Town of Jackson Design Guidelines Checklist

Item Number: P23-098

Address: 105 E. Broadway Avenue

PROJECT: "KING OF BROADWAY" at 105 E Broadway, Jackson, WY

FLOOR PLAN - LEVEL 2
NEW - PROPOSED

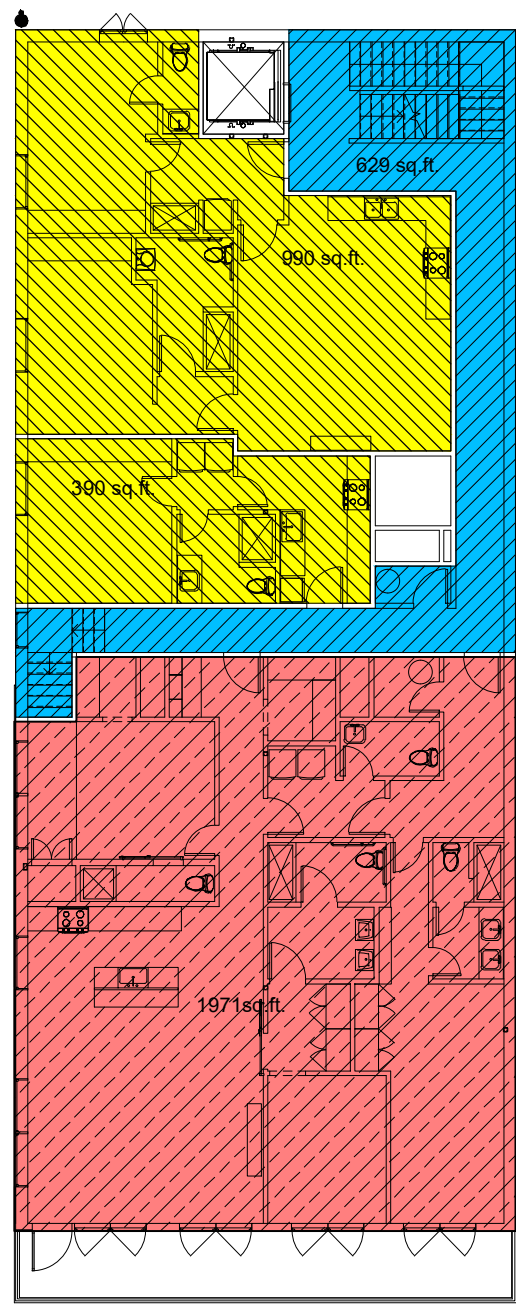
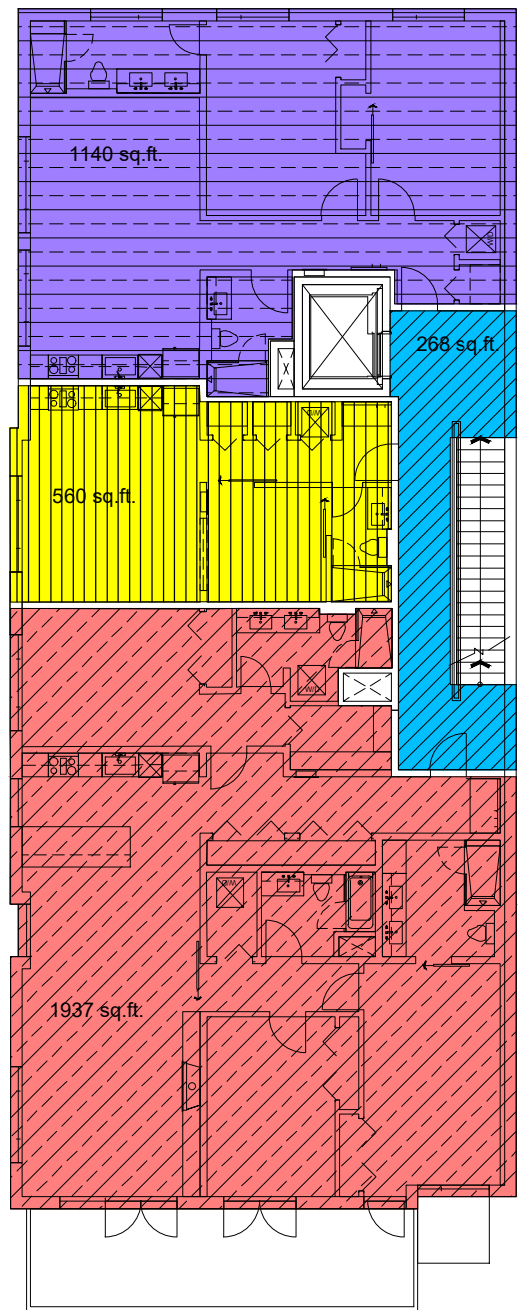
2. The balcony is too large both in projection and thickness and doesn't mesh well with the overall design/theme. One suggestion was that the 2nd story railing could be pulled further back from the balcony to reduce its perceived mass and impact on the public ROW. If the private balcony is proposed to extend into the public ROW, this shall require future approval from the Town Council of an encroachment agreement, which may not be approved. The design should consider the possibility that such approval will not be granted and that the private balcony and railing will extend no farther than the applicant's front property line.

- Level 2 Balcony is reduced to 8'-6" as recommended by DRC.
- Railing on L2 balcony is setback to provide planter.
- Soffit @ L2 Balcony is made of lighter colored siding as recommended.
- Canopy is provided at Residential Entrance.
- East wall toward Belle Cose is done in two-tone CMU w/ precast ledger.
- Canopy on Level 2 & 3 is changed to sunshade.
- Materials shown on elevations.
- Varying the size/scale of the wood siding between light and dark.

NEW - PROPOSED DESIGN

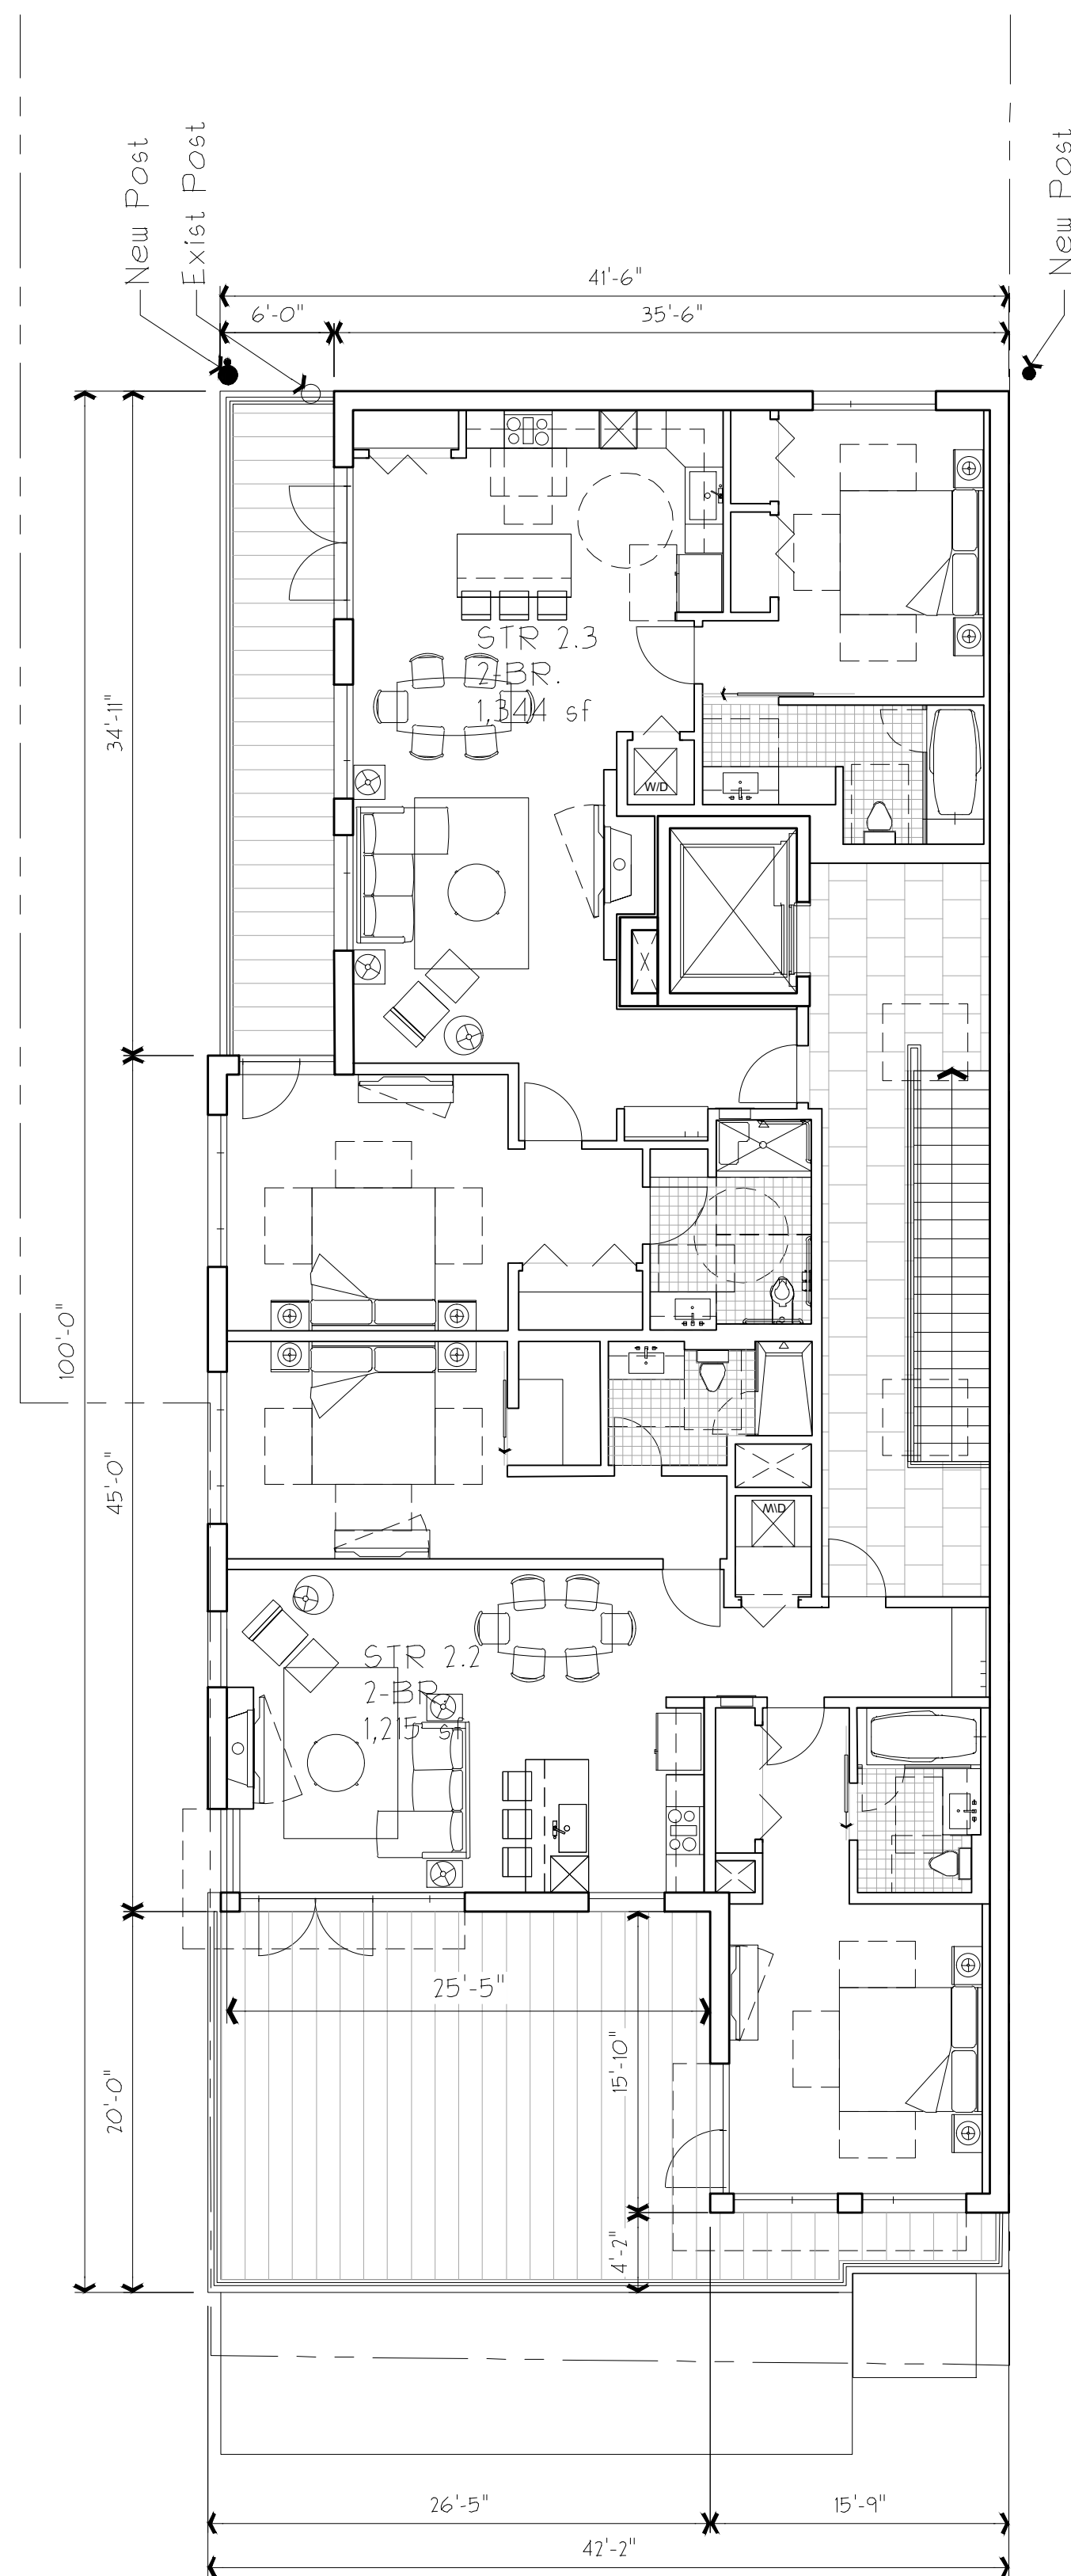
3. The covered walkway needs to continue across the entirety of the building frontage to protect the wood boardwalk and be reduced in depth to be at least 18" back from the curb.

4. The east elevation, especially the 3rd level, is highly visible and needs additional architectural improvements to improve the appearance. Suggestions include wrapping materials further around the east side and changing the color of the CMU to something lighter versus dark gray.
